SAFETY RECALL NOTICE

SAFETY RECALL CAMPAIGN #13E-042

Dear Owner of Apex 3™ Bicycle Rack:

FIGURE 1: APEX REVISION SCHEMATIC

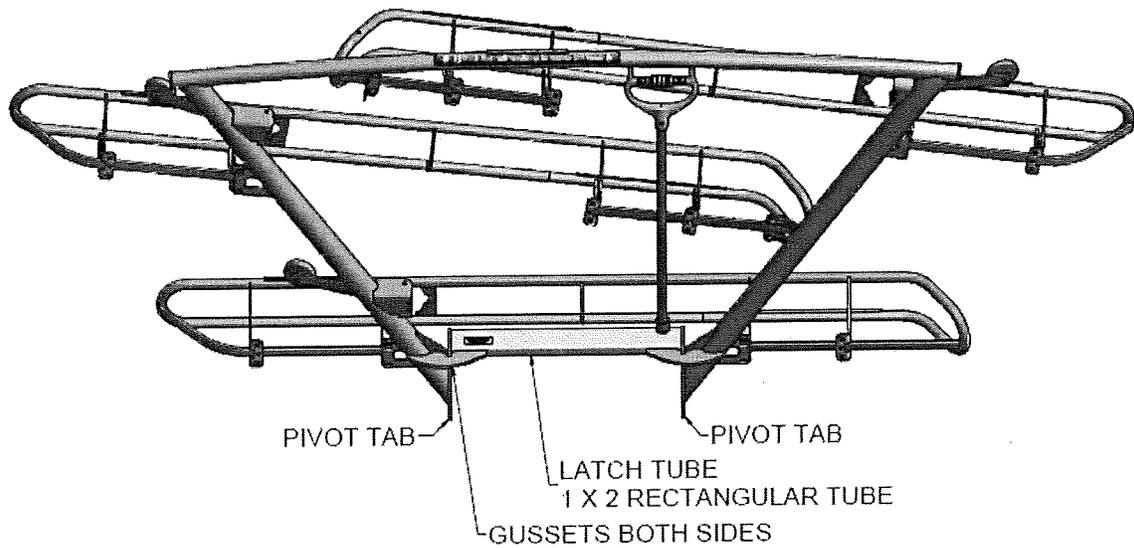
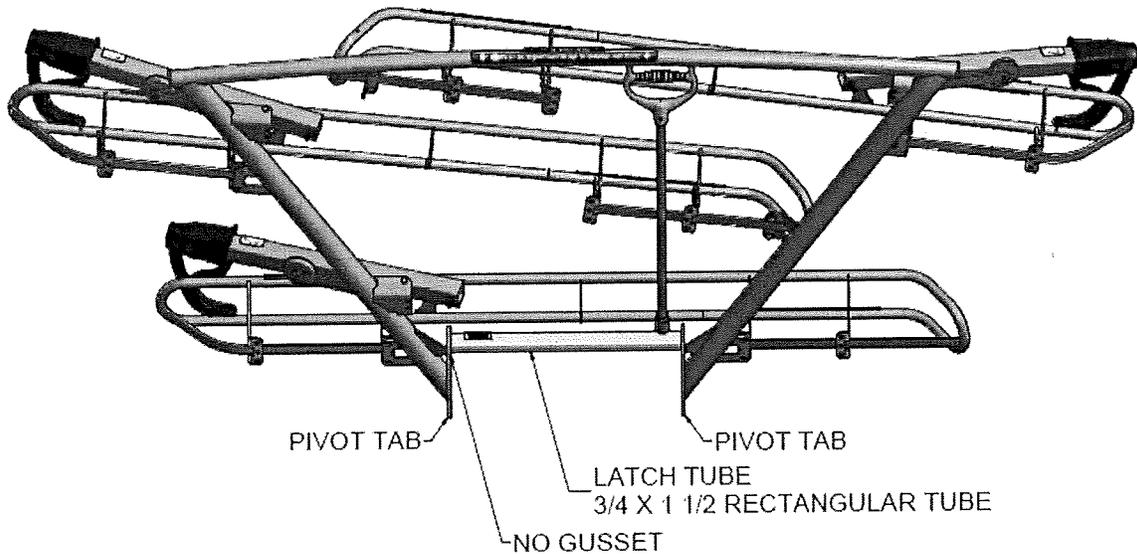
The possibility exists that cracks may develop where the latch tube is welded to the pivot tabs connected to the rack frame.

NOTE: Apex 3™ units manufactured after April 8, 2013 have a larger rectangular tube and gussets supporting the weld between the new latch tube and round frame tubing and are not included in this recall (see Figure 1 attached).

Sportworks will facilitate the replacement of the frame of your recalled Apex 3™ bicycle rack free of charge.

FIGURE 2: APEX RACK INSPECTION

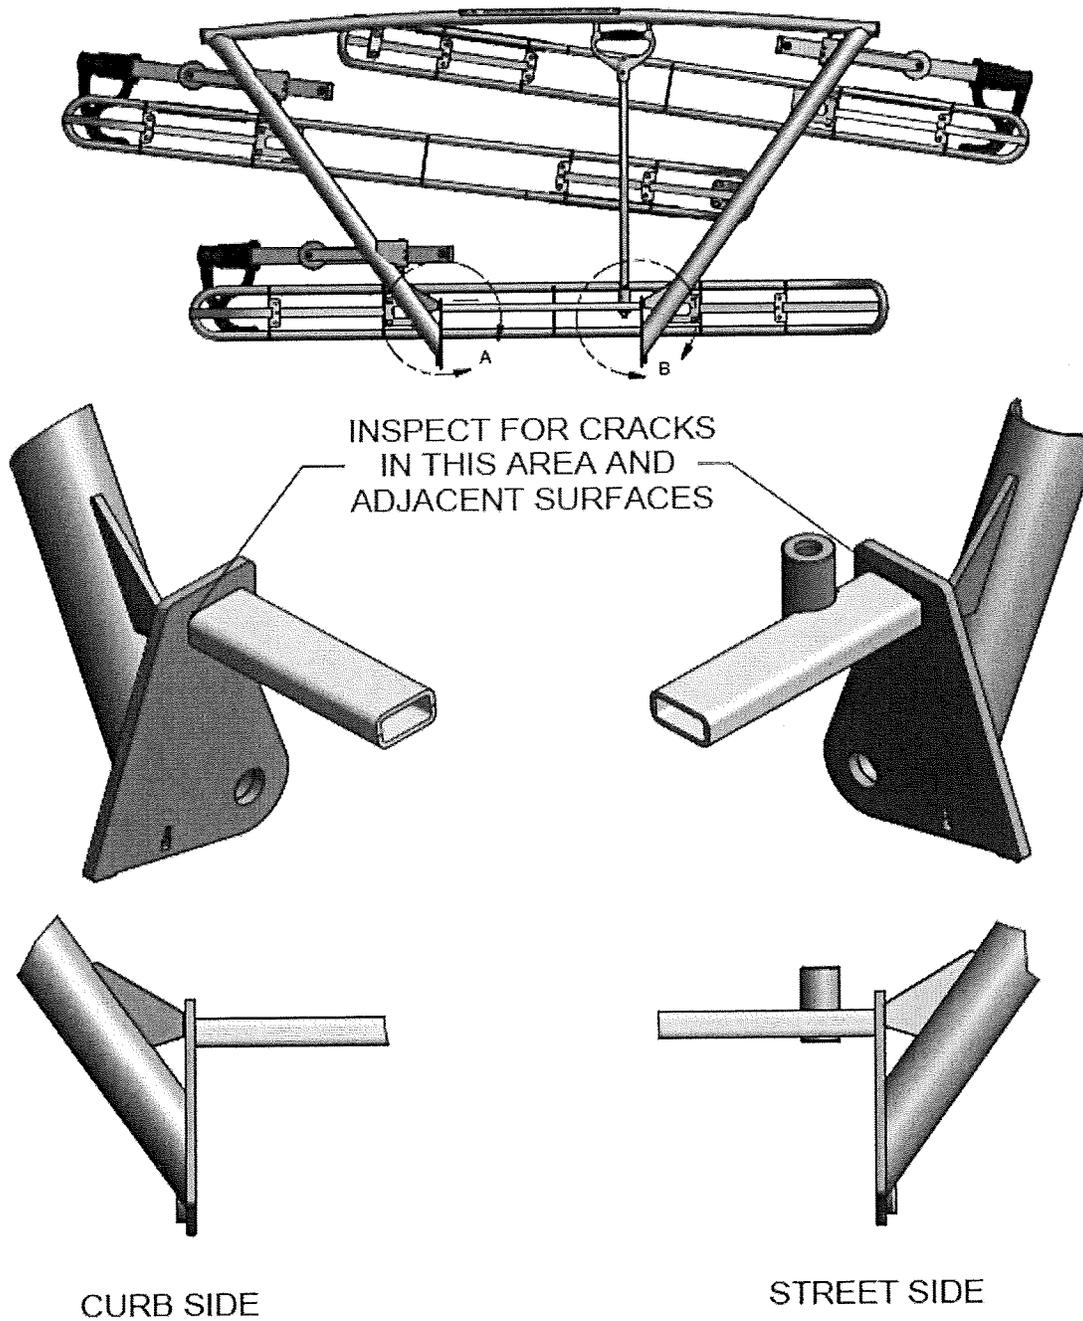
- Inspect rack for cracks that may develop where the rectangular latch tube is welded to the two pivot tabs (see Figure 2 attached).
- If cracks are visible, the Apex 3™ bicycle rack should be removed from the vehicle and not used until the frame is replaced.
- If cracks are not visible, cracks may develop over time and Sportworks highly recommends that the Apex 3™ bicycle rack be removed from the vehicle and not used until the frame is replaced.
